### Auckland Council Model Review Form

# Auckland Council Model Review

## Section 1 - Model Metadata

General Model Info	
Main Consolidated SW Catchment:	Wellsford
Council Project Manager	
Other SW Catchment within Model Extent:	None
Other relevant SW Catchment for model inputs:	N/A
Model Name:	Wellsford
Model Horizon ID:	
Model Software, AND Version:	Infoworks ICM 2021.6
Type of Model:	Flood Hazard Model (FHM)
Model Created By (Person/Organisation):	Miguel Hernandez, Woods
Is this model an update based on a previous model?	NO
Is the model built as per the SW Modelling Specs?	YES
Model Description:	1D/2D model of Wellsford catchment. The 2D model extent covers the northeast part of this catchment. The model includes a 1D representation of the Oruawhoro river. Main culverts along SH1 and the railway were included to represent the connection between the floodplain areas. Model extent is shown in Figure 1.
Model Purpose / Objectives:	Make a flood assessment for the proposed development located in the northeast part of the Wellsford urban area. The model is focused on the flood impact near the open channels and creeks. The development considers a future urban plan change. The model i

Figure B:1.4 Boundary conditions

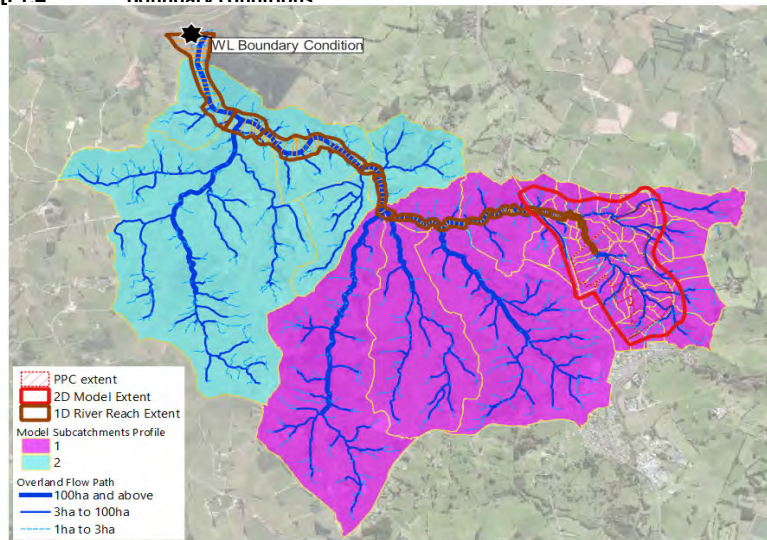
B:1.4	Check how model initial conditions are applied for both 1D and 2D. The use of model features such as initial condition zone for tidal areas and ponds, etc.	0	Checked. The tidal boundary (3.3mRL) at the end of the Oriawharo river reaches is the only boundary level condition. The minimum base flow depth for river reach is 0.02m. It was assumed dry conditions on the 2D surface at initialisation.		
B:1.5	Check time varying inputs and make sure their start and finish time aligns with simulation setting.	0	Checked and no issues found.		
B:1.6	How is climate change applied? Check rainfall and tide boundary	0	Rainfall depths are updated with the latest AC specifications which consider a temperature increment of 3.8°C.		
<b>B:2 - Model Catchments</b>

Figure B:4.2

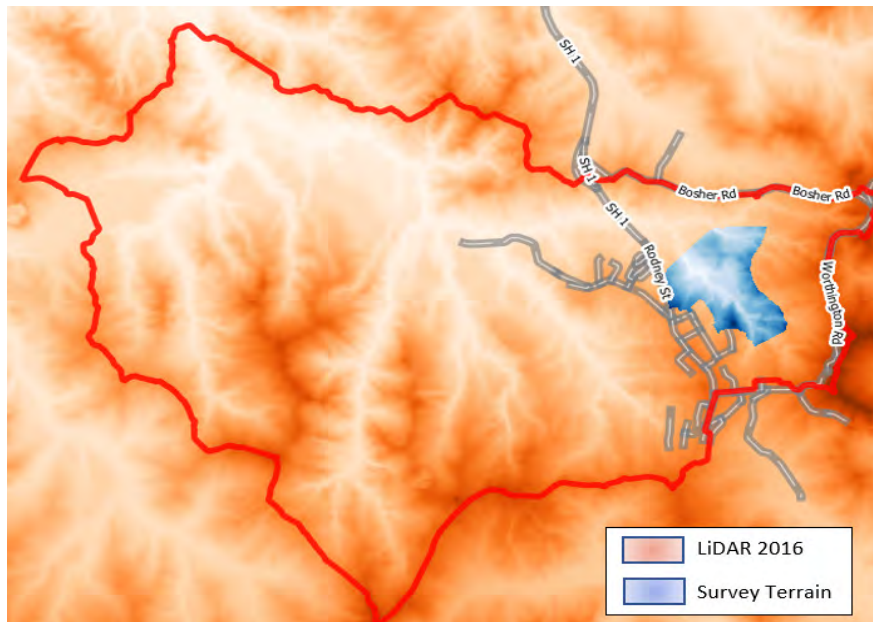
Item	Description	Rating Score	Modeller's Initial Notes	Reviewer's Comments	Modellers Response
B:4.1	Are channels modelled appropriately? (in 2D or as 1D river reaches)	0	1D Channel- Oruawharo River: Downstream SH1, 5100 meters. Upstream SH1, 850 meters. Checked		
B:4.2	In case of burning surveyed cross-sections in 2D, spot check cross-sections from 2D bathymetry compared to the surveyed cross-sections.	0	Checked. Cross sections have been taken from LiDAR2016 and survey. Five burnt areas have been implemented as mesh level zone in ICM. See survey area on Figure B:4.2		
B:4.3	Spot check modelled cross-sections and banklines with LiDAR	N/A	Checked and no issues were found. Cross-sections have been taken from LiDAR2016. Few spot heights around the main culvert (2000811317) were taken to confirm levels (no cross section survey)

Figure B:8.5

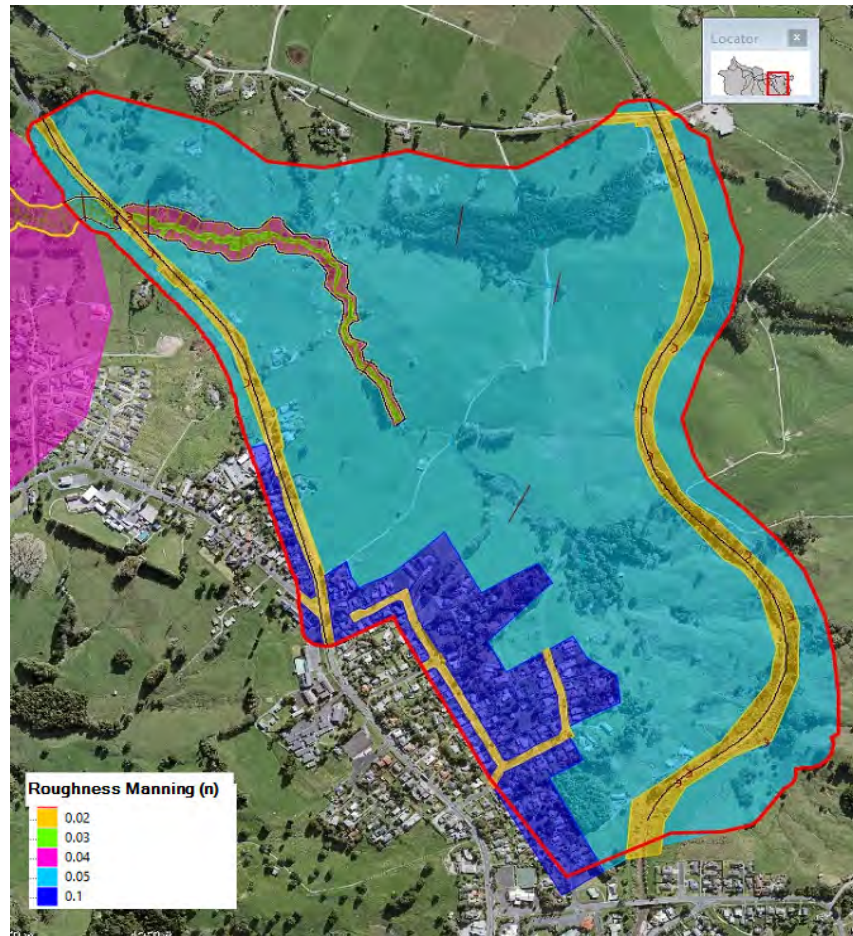
Item	Description	Rating Score	Modeller's Initial Notes	Reviewer's Comments	Modellers Response
B:8.1	Review 2D extent and mesh sizes (any terrain sensitive meshing, and no extremely large or small meshes) Are mesh sizes appropriate at inlets and outlets.	0	2D extent is focused on where the proposed development plan change is located.		
B:8.2	How have building footprints been represented	0	No building footprints are represented on the mesh. They were used as an impervious area in the runoff calculation.		
B:8.3	Review DEM and identify if any errors in DEM, e.g. around buildings	0	Used Lidar 2016 (latest data captured by AC)		
B:8.4	Check representation of any key obstructions	0	n/a		
B:8.5	Check roughness zones and values	0	Roughness values are shown in Figure B:5.5. Values were taken as per the Table 5.4 Stormwater Flood Modelling specification (2011). Figure B:5.5 shows the roughness. As the catchments are loading directly to open channels, no overland flow is modelled near existing buildings; therefore, no building roughness was considered on the 2D surface.
